Access Compliance Report

Public Rights-of-Way

Intersection ID: 11660	Main Street: E_20TH_ST	Cross Street: HARRILL_ST	Location: S
ADA ID: 1CBDAE84C67D	Ramp Type: PerpDiag	Initial Pass/Fail: Fail	Overall Compliance: No
Severity Score: 10			
Codes/Mitigation Info/Possible Solution		Field Measurements/Component Compliance

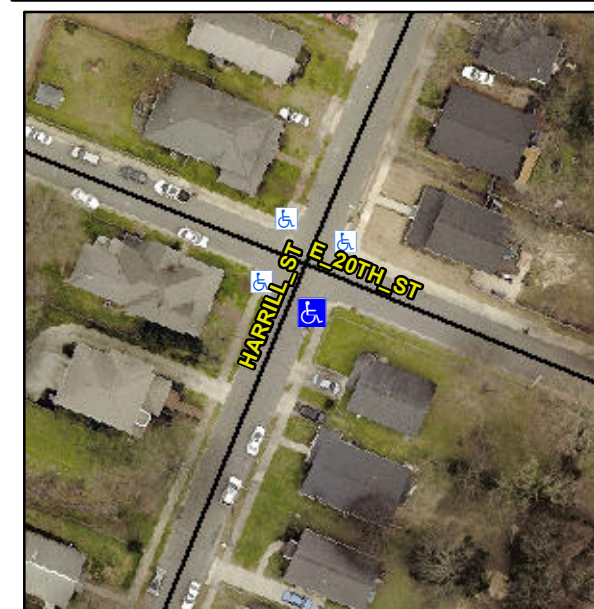
Not Found, R304.5.1, R304.5.3

Compliance	Description	Data	Compliance	Description	Data
N/A	Ramp Length (in)	25.0	Yes	Ramp Slope (%)	6.8
No	Ramp Width (in)	41.0	No	Ramp XSlope (%)	3.0
N/A	Flare Type LT	N/A	N/A	Flare Type RT	N/A
N/A	Flare Slope LT (%)	N/A	N/A	Flare Slope RT (%)	N/A
N/A	Flare Traversable LT?	N/A	N/A	Flare Traversable RT?	N/A
N/A	Landing Length (in)	N/A	N/A	DWS Provided?	N/A
N/A	Landing Width (in)	N/A	N/A	DWS Contrast?	N/A
N/A	Landing Slope (%)	N/A	N/A	DWS Length (in)	N/A
N/A	Landing X Slope (%)	N/A	N/A	DWS Full Width?	N/A
N/A	Landing Curb? (Y/N)	N/A	N/A	DWS Offset (in)	N/A
N/A	Shared Landing?	N/A			
N/A	Gutter Ponding?	N/A	N/A	Gutter Slope (%)	N/A
N/A	Gutter Lip Ht (in)	N/A	N/A	Gutter X Slope (%)	N/A
N/A	Painted X Walk1?	No	N/A	Painted X Walk2?	No
	X Walk 1 Direction	To NE		X Walk 2 Direction	To NW
N/A	X Walk 1 Width (in)	N/A	N/A	X Walk 2 Width (in)	N/A
	X Walk 1 Slope (%)	5.7		X Walk 2 Slope (%)	2.2
	X Walk 1 X Slope (%)	3.7		X Walk 2 X Slope (%)	3.6

Remove & Replace Curb Ramp With Two New Directional Ramps or Equivalent.
